Subject: Comments on item 4.7 California St. and 4.8 Middlefield Road

Subject: Fwd: 5/28 Meeting - Agenda Item 4.8 Middlefield Road "Complete" Street

Subject: 4.8 Annual Street Maintenance (Middlefield Road Complete Streets), Project 22-01 - Professional

Attachments: Middlefield signage photo.jpg

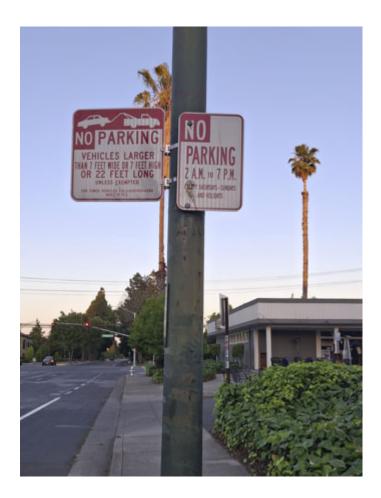
I also ask that a review of the signage is included. For a long time, I glanced at these signs, and thought "ok - no overnight parking." It was only much later that I realized the no parking extended all the way to 7pm. And, if there is finally no parking at all in certain stretches, I hope unneeded signs can be taken down.
